Addendum No. 2
October 23, 2025

Project: Beresford High School Addition
Beresford, South Dakota
Project #2979

Architect: Architecture Incorporated

2 NEW OPENING IN EXISTING COMMONS EAST WALL
1" = 1'-0"

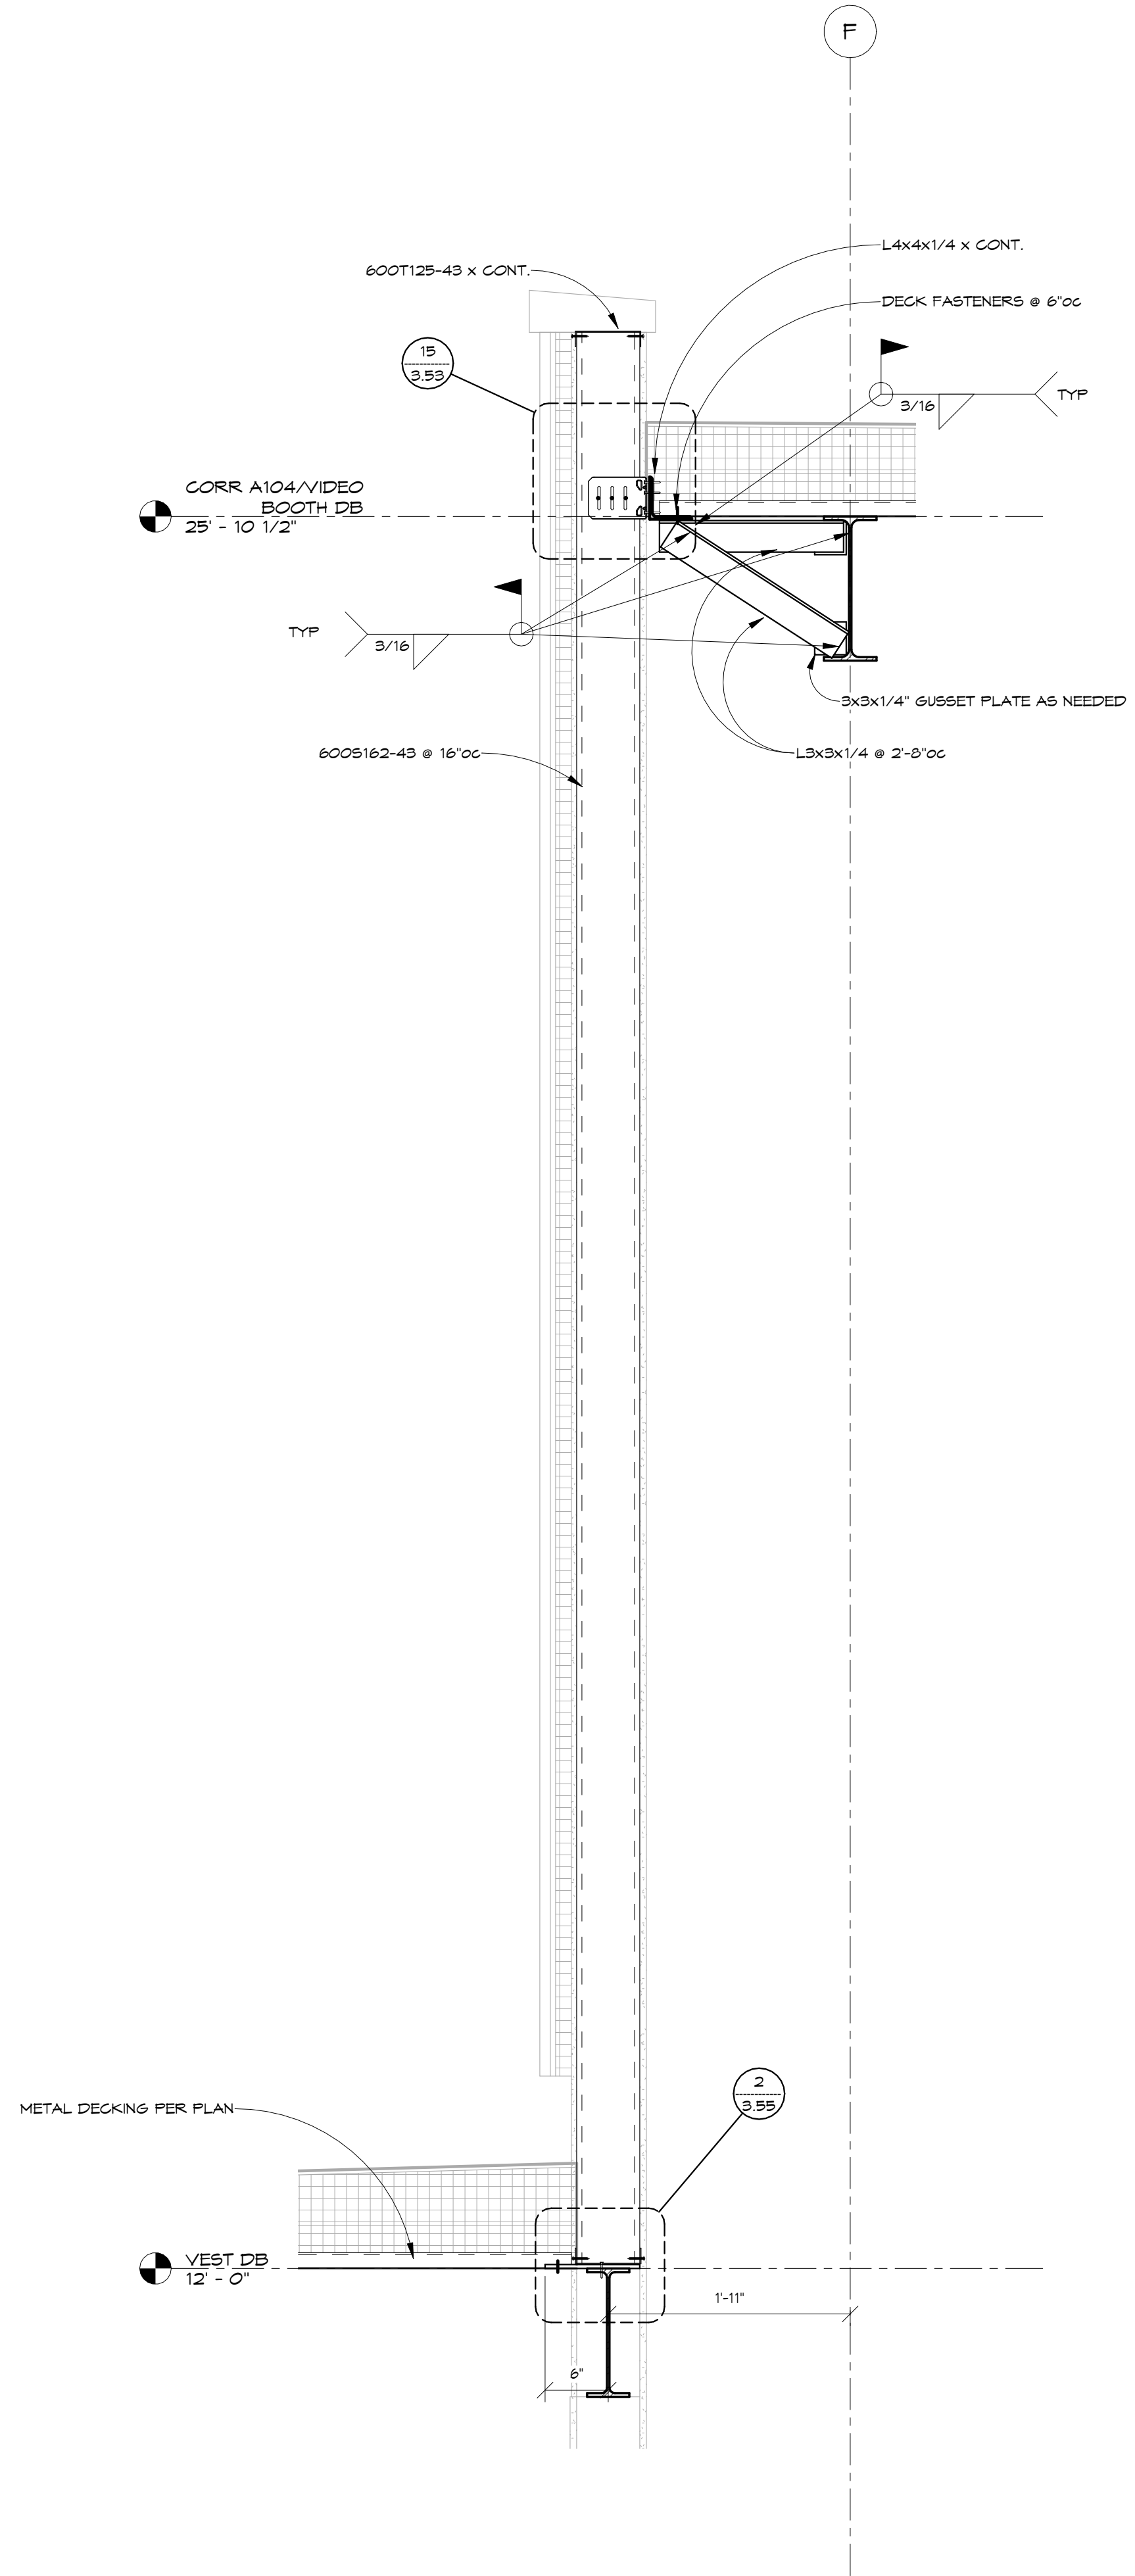
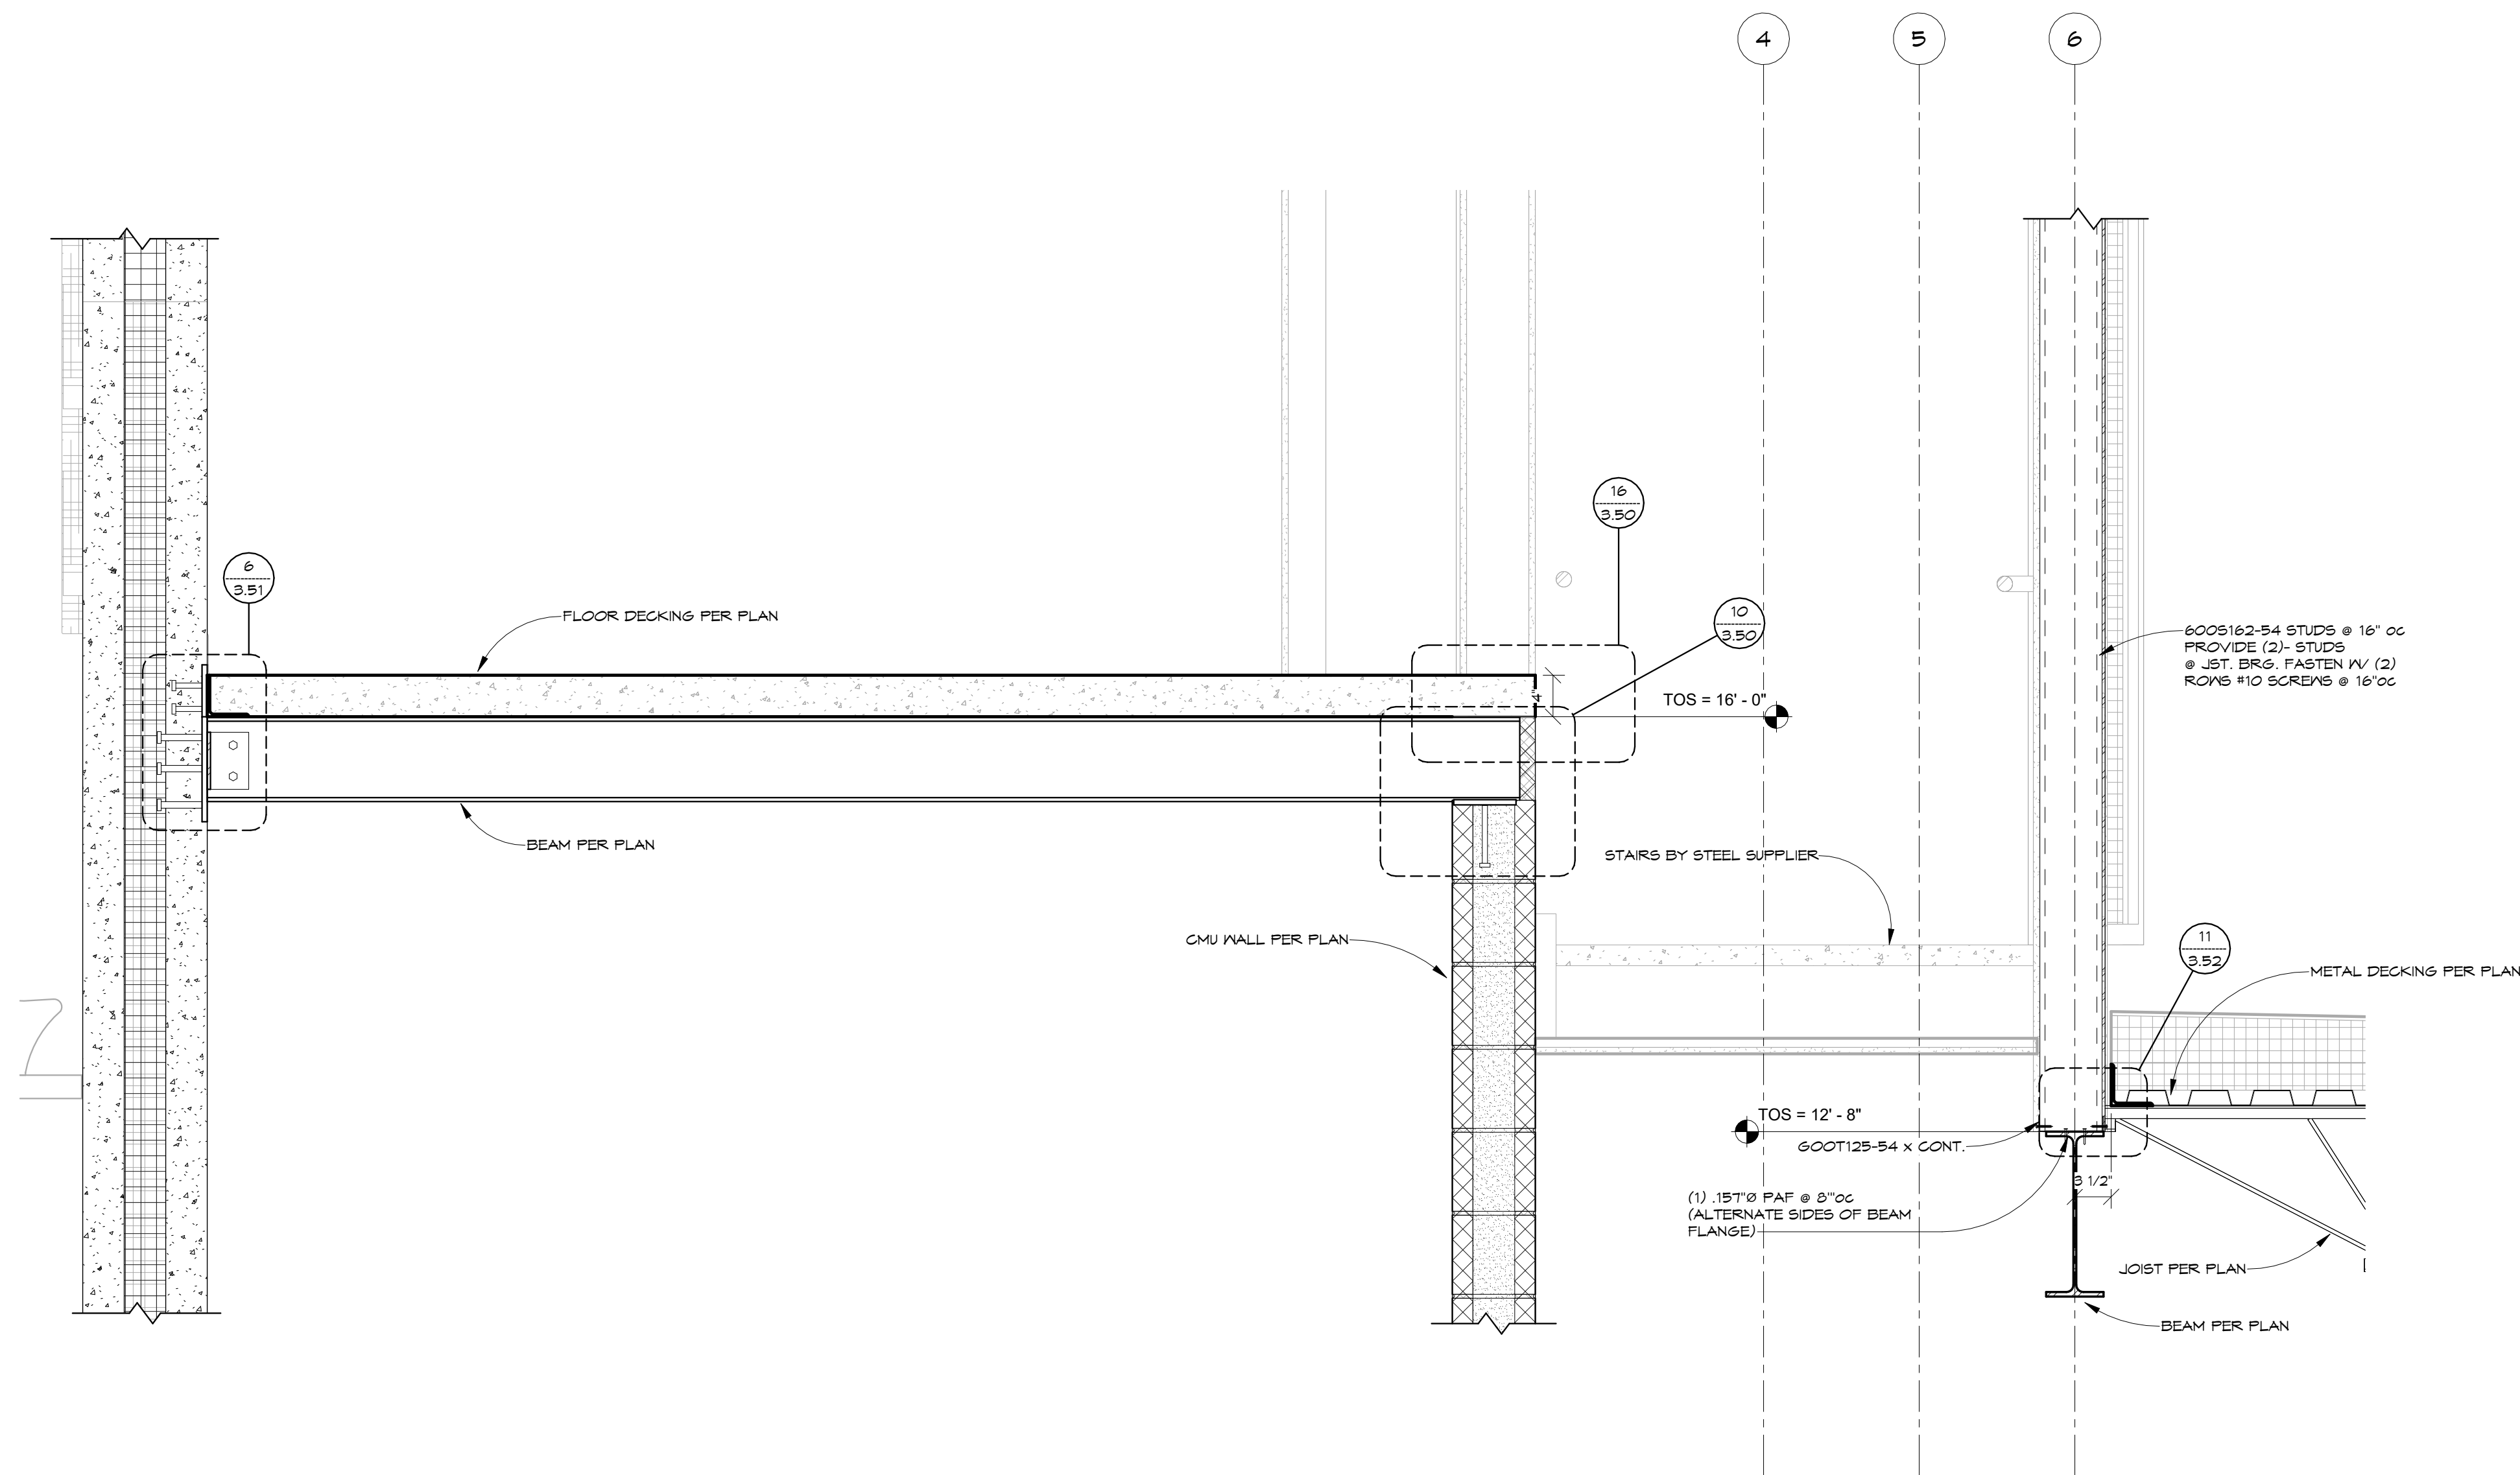
- i) Detail 1/3.59: Add shoring notes and connections per clouded on the *revised* sheet.
- ii) Detail 2/3.59: Add shoring notes and connections per clouded on the *revised* sheet.

8 PLAN AREA - AREA A
4.40 SCALE: 1 1/2" = 1'-0"

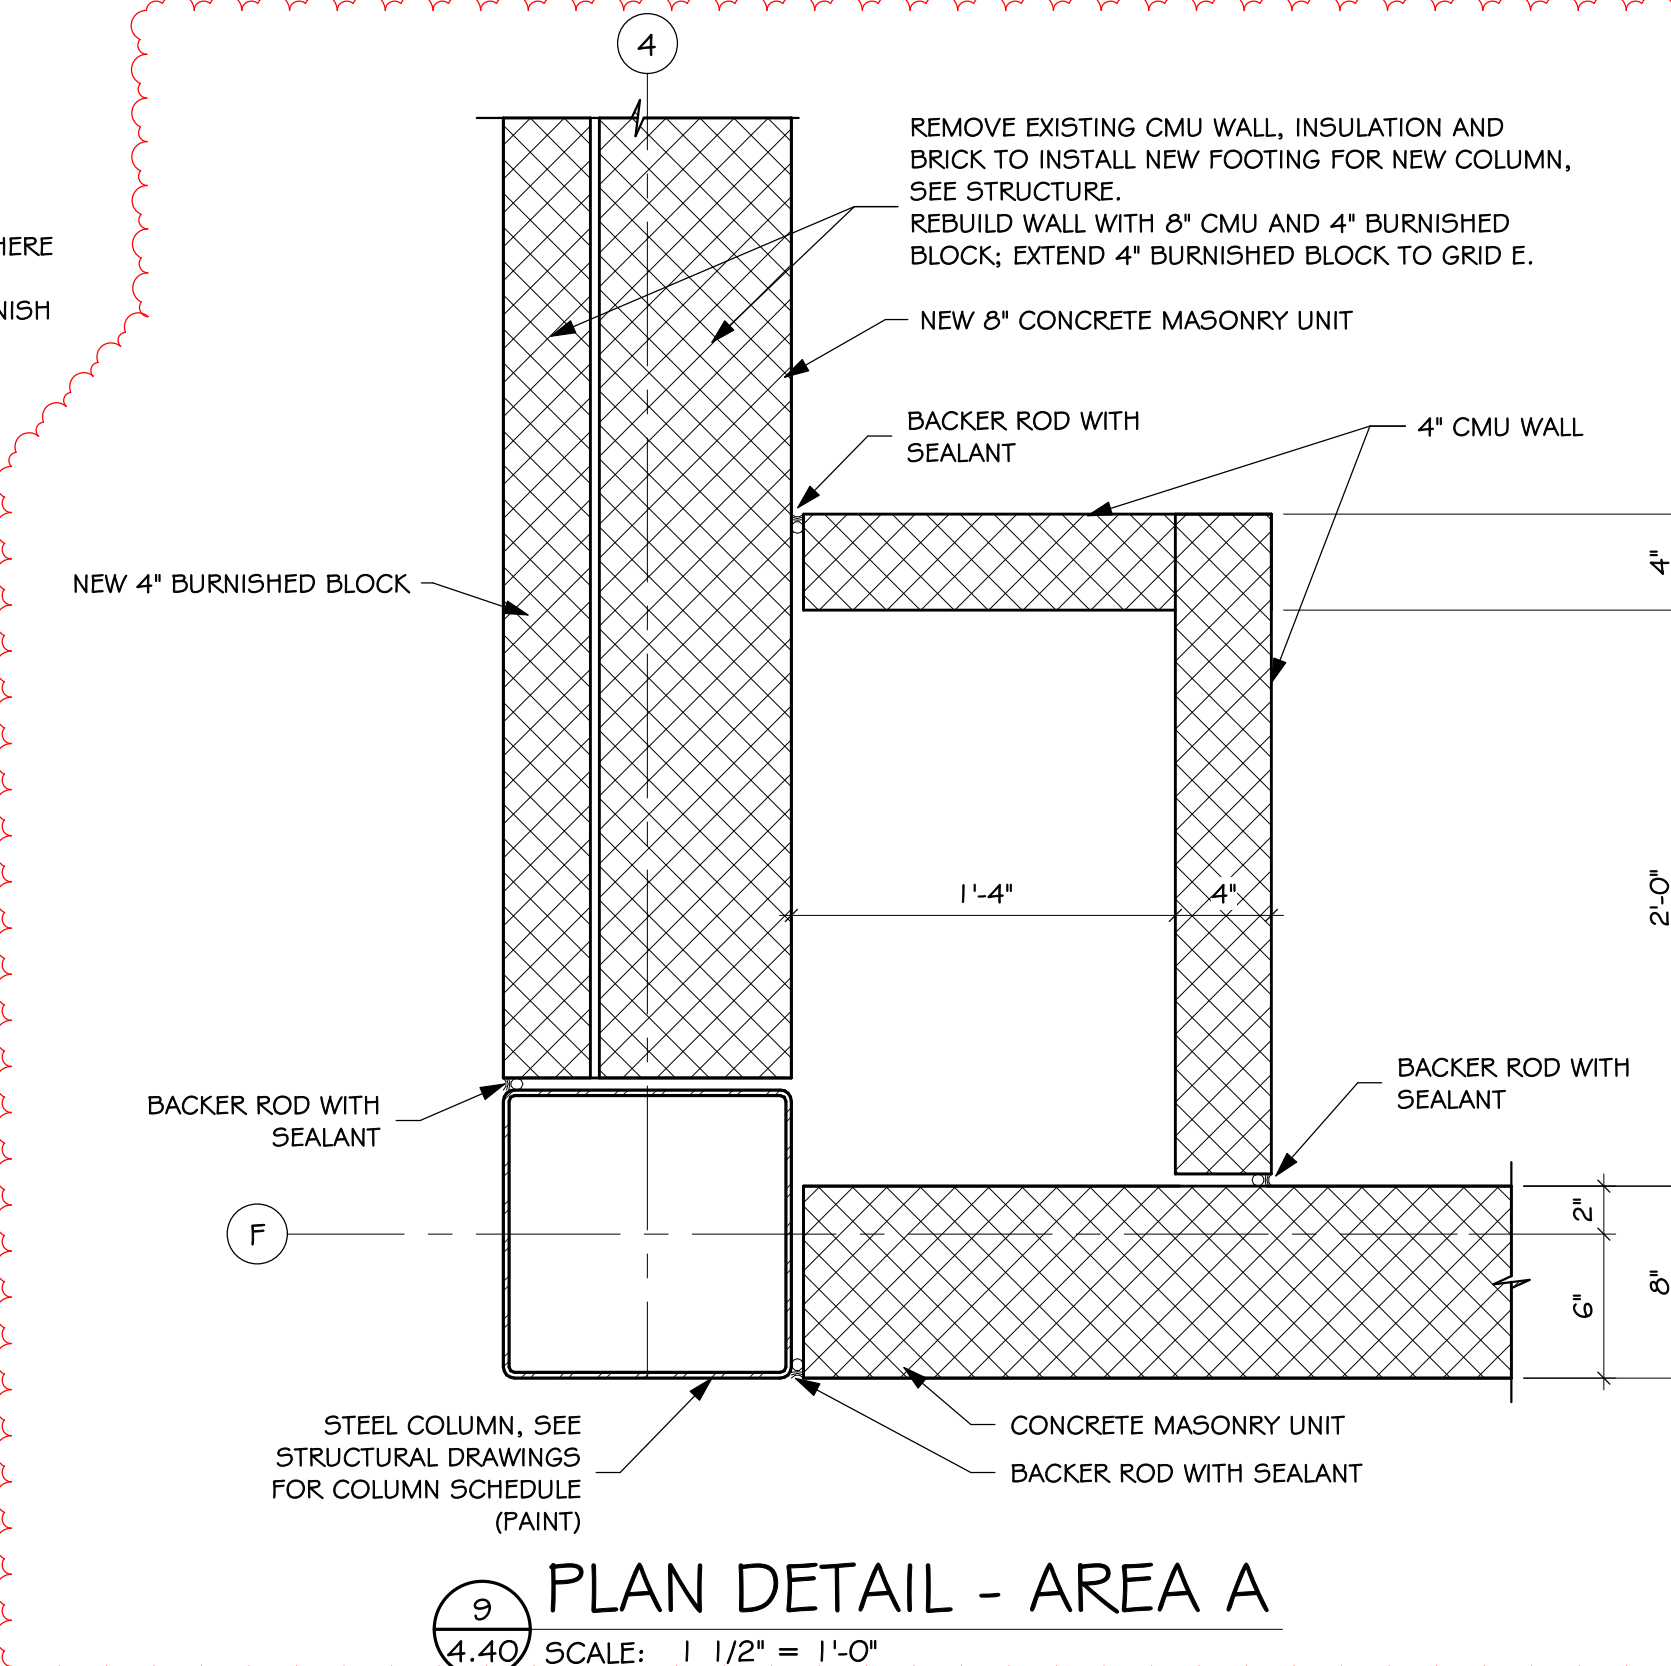
- a) Refer to *revised* sheet 4.40, *revision* dated 10-23-2025, attached to the end of this addendum for following modifications.
 - i) Detail 8/4.40 & 9/4.40: Remove existing brick, insulation and concrete masonry wall as needed to install new footing for new steel column; refer to structural sheet 3.20A. Rebuild wall with 8" CMU and 4" burnished CMU as shown in revised details. Burnished CMU extends vertically to above ceiling and remainder of 4" CMU above ceiling is standard finish. Burnished CMU extends horizontally to Grid E as shown in *revised* detail 8/4.40.
